SUBJECT: RADIOLOGICAL EFFLUENT TECHNICAL SPECIFICATIONS (RETS)

Re: Brunswick Steam Electric Plant, Unit Nos. 1 and 2

## TRIP REPORT

Date of Trip: 10/5/82  
Project: 504-5506-001  
FRC Assignment: 4  
FRC Tasks: 085, 086  
Radiological Effluent Technical  
Specification Implementation

Figure 1. Liquid Radwaste and Effluent Pathways for Brunswick Steam Electric Plant Units 1 and 2

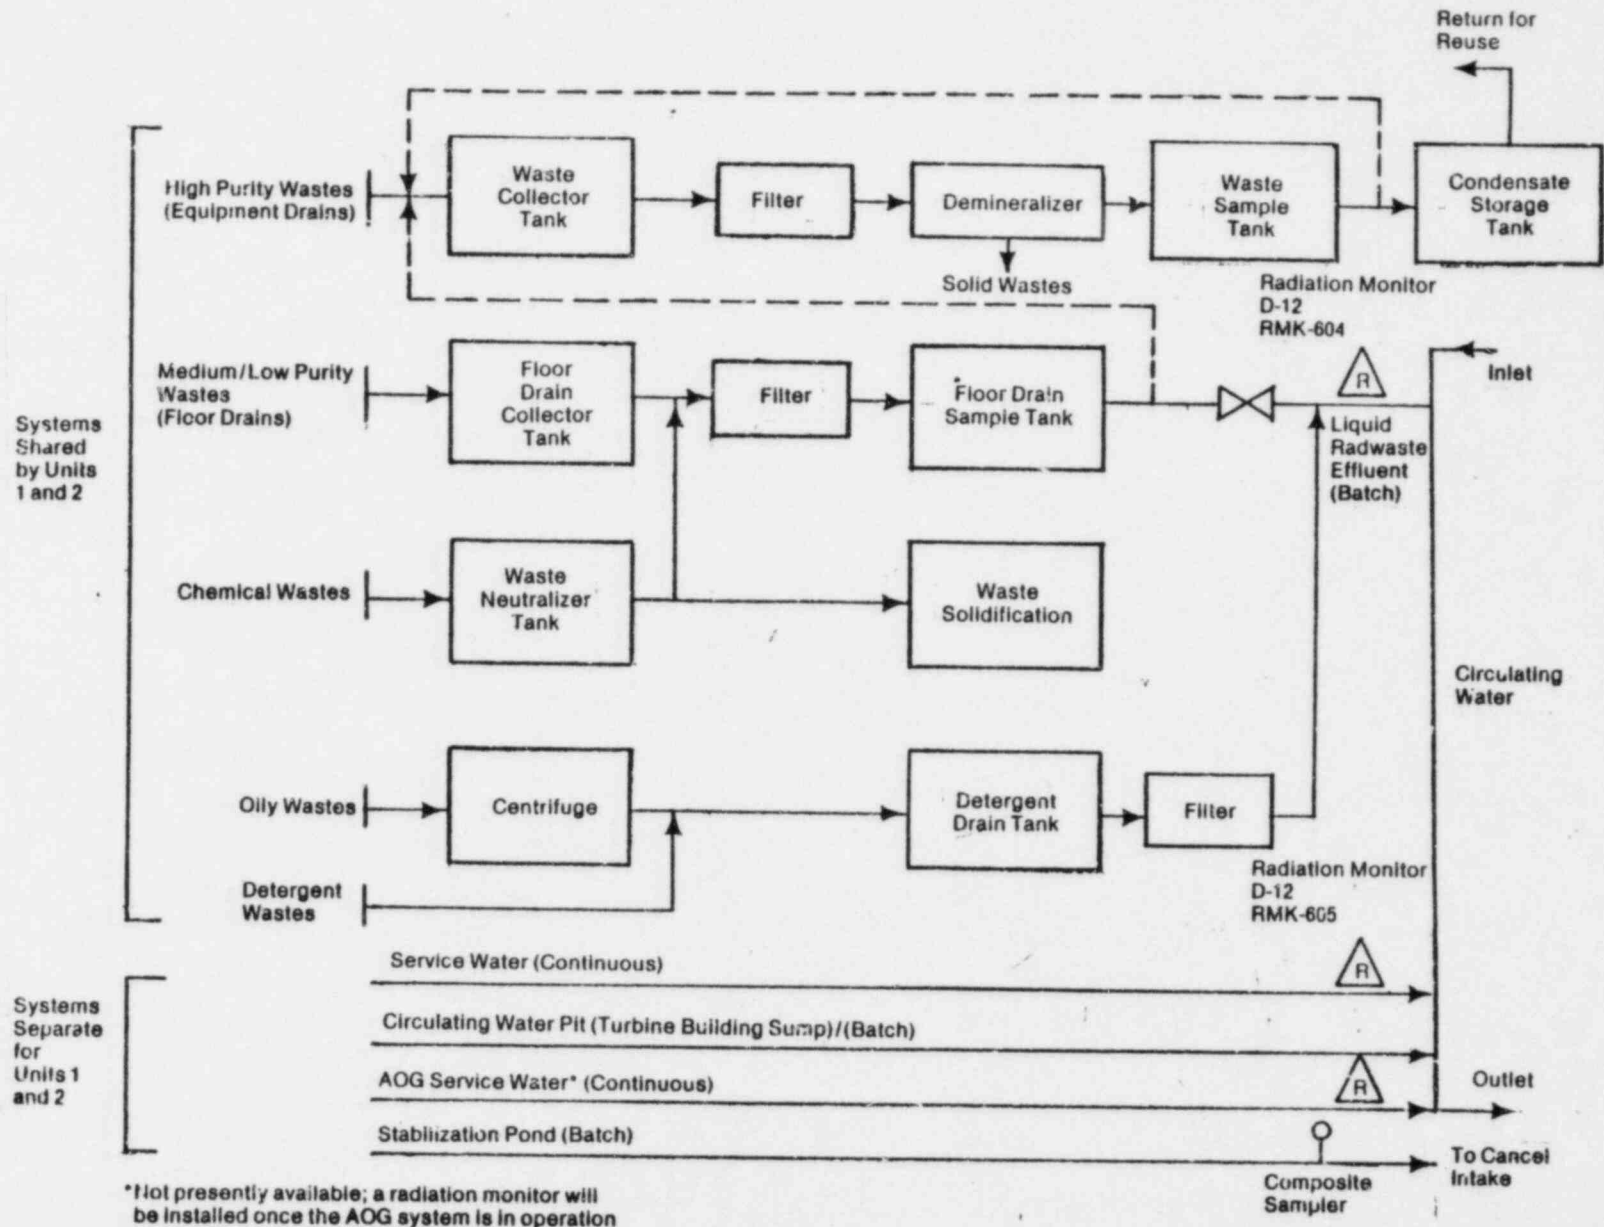
Both units of the Brunswick plant are boiling water reactors. Major liquid effluents are discharged via the liquid radwaste effluent line (Figure 1). Although this effluent path handles the majority of the radioactive discharges, the effluents are normally collected, processed, and monitored before being released in batches. A radiation monitor (D-12, RMK-604) has been installed for this effluent path, which also provides automatic isolation in the event that an excessive level of radioactivity is detected.

Other potential effluent lines are the service water line, effluent from stabilization pond, and the turbine building sump. Among these, the service water line has a monitor (D-12, RMK-605), and the stabilization pond has a composite sampler. The turbine building (circulating water pit) sump does not have a monitor or a composite sampler. However, the Licensee explained that the sump effluents normally contain only low-level activities and are collected and grab-sampled. They are released in batches only if the activity level meets the requirement. To prevent inadvertent releases, the Licensee will also lock the valve if the releases are not being made.

The Licensee plans to install the augmented offgas treatment (AOG) system in the near future, and has identified the service water effluent from the AOG precooler as another potential effluent line. The Licensee will install a radiation monitor for this effluent line but as yet is unable to designate that monitor by an ID number.

- o Component Cooling Water Effluent Line: The Licensee did not enlist component cooling water as an effluent line on the basis that the component cooling water is a closed loop, and that any leakage will eventually go to the service water line where the radiation monitor will indicate the contamination. FRC requested that better justification or an alternative be provided since any leakage will be diluted by the large amount of service water and that the service water detector will not be sensitive to the leakage in the component cooling water. The Licensee agreed to provide a better justification.

Figure 2. Gaseous Radwaste and Effluent Pathways for Brunswick Steam Electric Plant Units 1 and 2

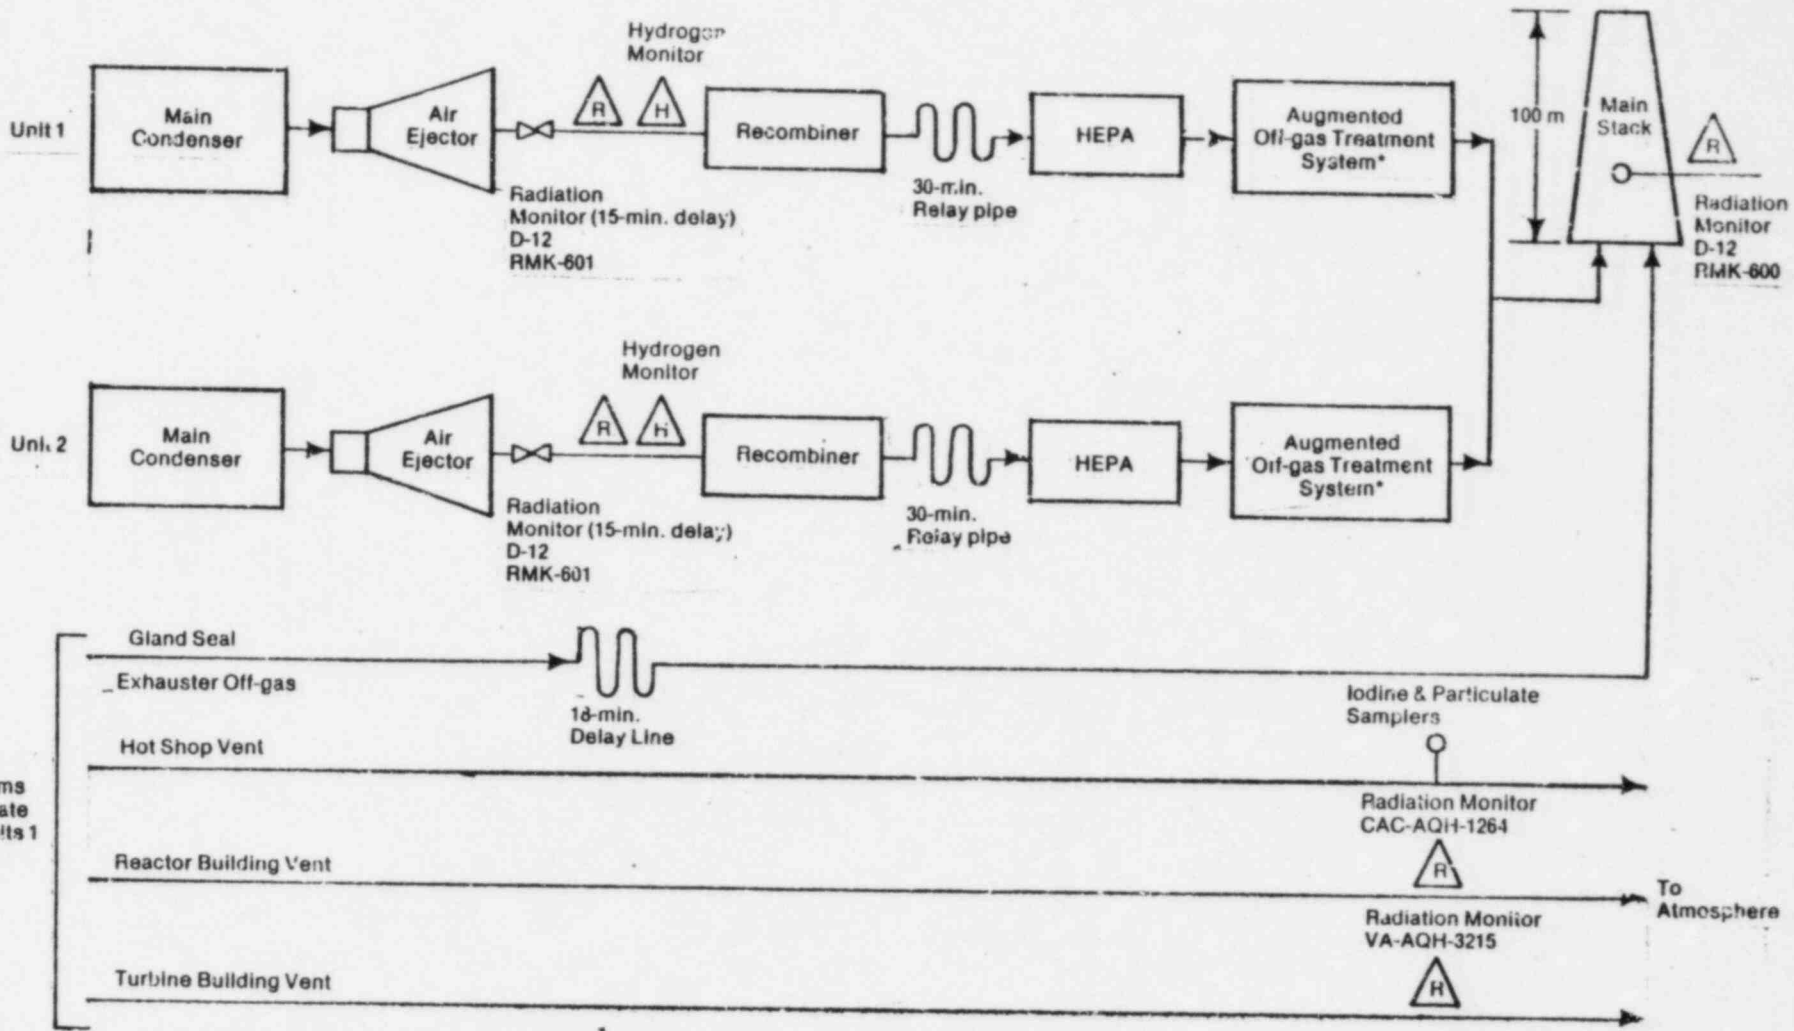
A gaseous radwaste system is provided for each unit of the Brunswick plant. The processed gases from each unit are routed to the plant stack for dilution and elevated release to the atmosphere (Figure 2). Each air ejector off-gas line and the stack are continually monitored by radiation monitors, designated by D-12, RMK-601 and D-12, RMK-600, respectively. The air ejector monitor is also capable of automatic isolation. The radwaste treatment system includes the 30-minute delay line and HEPA filters for each unit. The AOG treatment system originally installed has been retired and is being replaced by an improved system. This situation is noted in pertinent sections throughout the Licensee's proposed RETS submittal.

Other effluent lines separate for each unit are from the reactor building vent (monitor CAC-AQH-1264), the turbine building vent (monitor VA-AQH-3215), and the hot shop (monitored only by iodine and particulate samplers).

Monitors will also be installed downstream of the AOG system once the system is up for operation.

- o Hot Shop Vent: This is a potential effluent line which was not included in the Licensee's RETS submittal. The Licensee agreed to enlist this in the future submittal but will commit only to iodine and particulate samplers for monitoring the radiation since noble gases are unlikely to contaminate the hot shop.
